City of Florence Water Treatment Plant

PROJECT: EAST FLORENCE VAULT MODIFICATIONS, MASTER METER REPLACEMENT AND BYPASS

Request For Proposals Questions And Official Responses

RFP No. 24

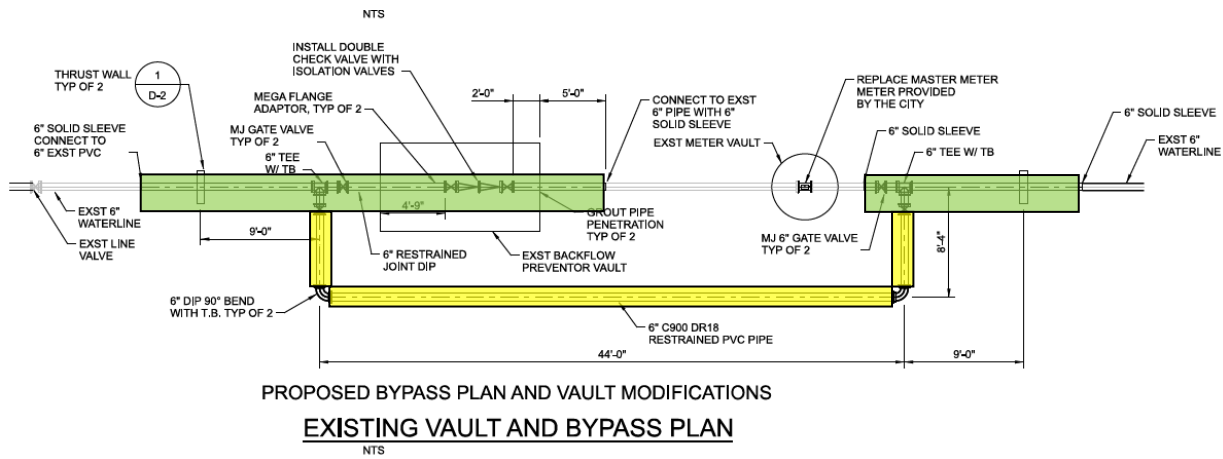
The Can you clarify where the DIP and C900 are to be used? There are only 2 callouts for type of the pipe. It appears the bypass portion of the pipe will be C900, and the pipe entering the new vault appears to be DIP. Does all of the pipe, including coming out of the new vault, need to be DIP as well?

Refer to the accompanying annotated drawing on the next page for clarification of the pipe material requirements. Sections highlighted in green indicate ductile iron pipe, and sections highlighted in yellow indicate C900 pipe.
